**PAID DIAGRAM FOR HYDRANT SYSTEM (INCLUDING P AND I DIAGRAM OF BOOSTER PUMP)**

**4410-001-151-PW-1-001**

**PROJECT:** 3 x 660 North Karanpura STPP

**Subject:** BHEL Replies against Customer comment on P&ID for Hydrant System- 4410-001-151-PVM-L-001-Rev 01

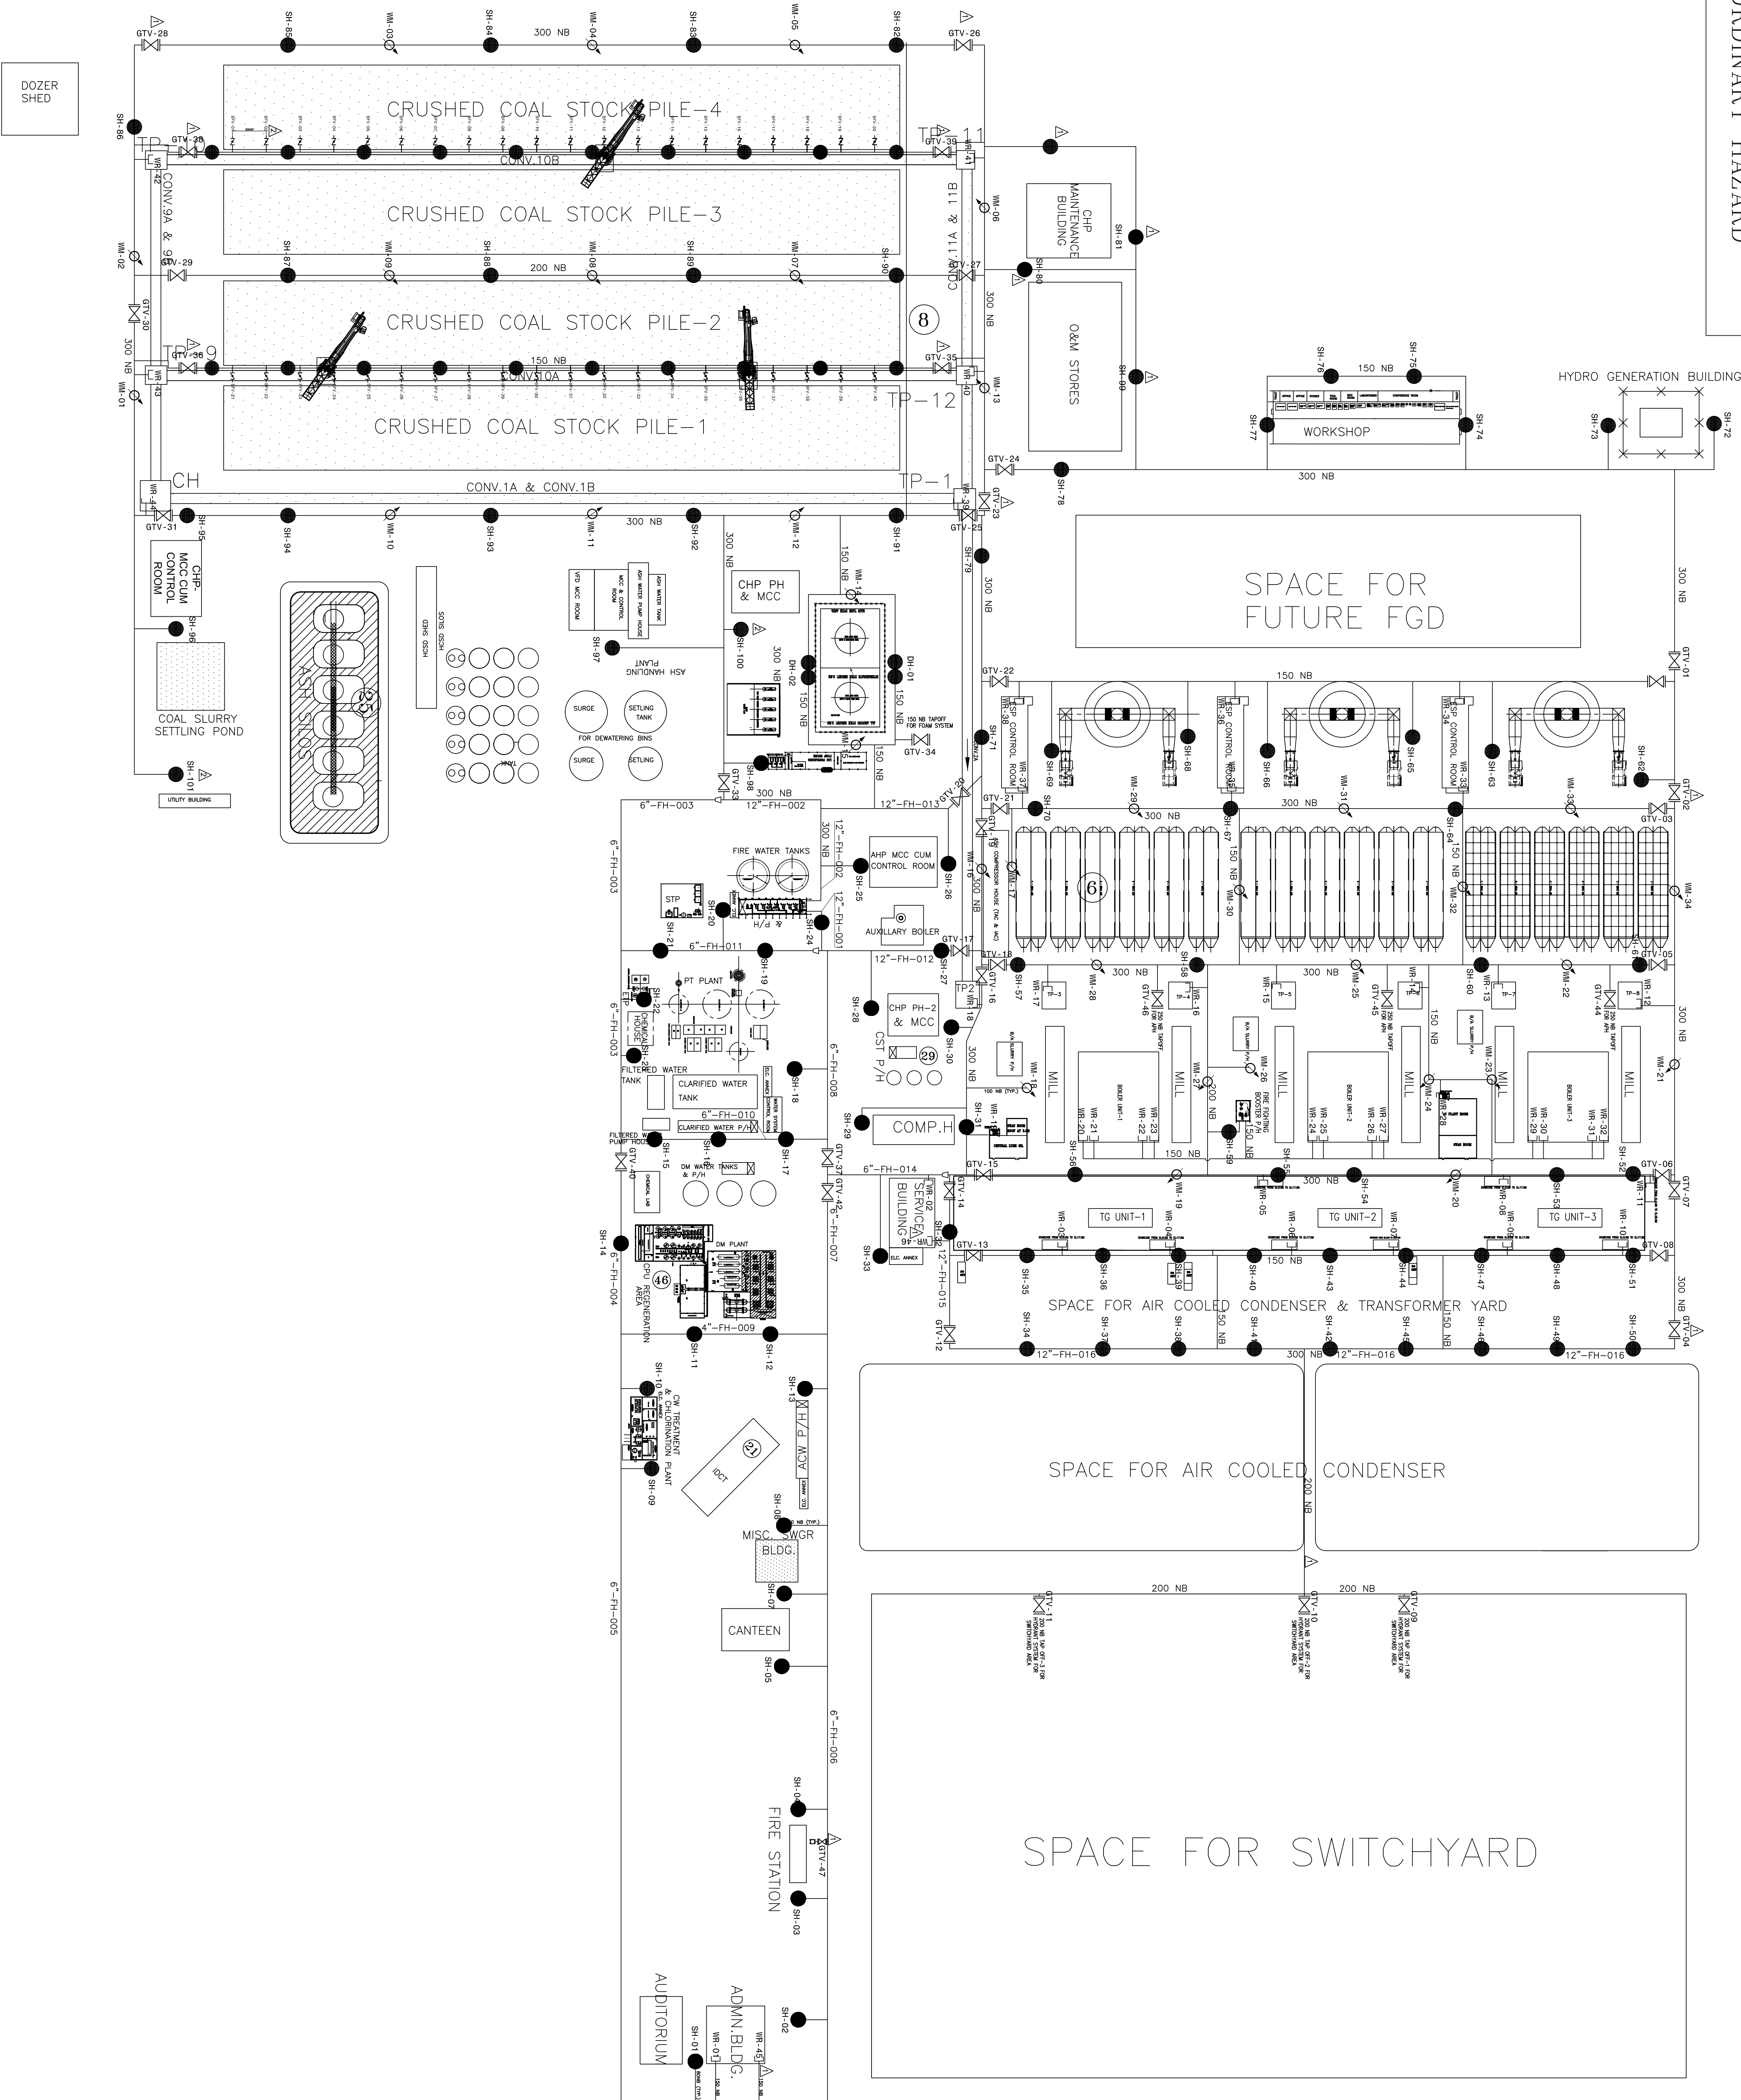
Sl. No.	NTPC Comments	BHEL Replies	NTPC Replies
1	Mention the dimension of facilities then only number of hydrants can be calculated	This is a conceptual drawing only. Dimensional details of respective buildings shall be indicated in the layout drawing. However, we confirm that spacing between hydrant points in the hydrant network shall not be more than 45 meters as per TAC cl. No. 7.6.11. We request you to accord approval on the same.	
2	CHP PH and MCC to be protected with Hydrant	Noted. Document revised according.	
3	Utility Building to be protected with Hydrant	Noted. Document revised according.	
4	As mentioned in last revision, all along these lines, butterfly valve @20 m need to be provided in hydrant line for MVW spray protection of stacker reclimer machine.	Noted. Document revised according.	
5	Make the dimension of Admin & Audi and provide the hydrants all along the building, as these seems not sufficient	This is a conceptual drawing only. Dimensional details of respective buildings shall be indicated in the layout drawing. However, we confirm that spacing between hydrant points in the hydrant network shall not be more than 45 meters as per TAC cl. No. 7.6.11. We request you to accord approval on the same.

6	This document shall be resubmitted after approval of various documents like area layout and FEH	This is a conceptual drawing only. Dimensional details of respective buildings shall be indicated in the layout drawing. However, we confirm that spacing between hydrant points in the hydrant network shall not be more than 45 meters as per TAC cl. No. 7.6.11. We request you to accord approval on the same.
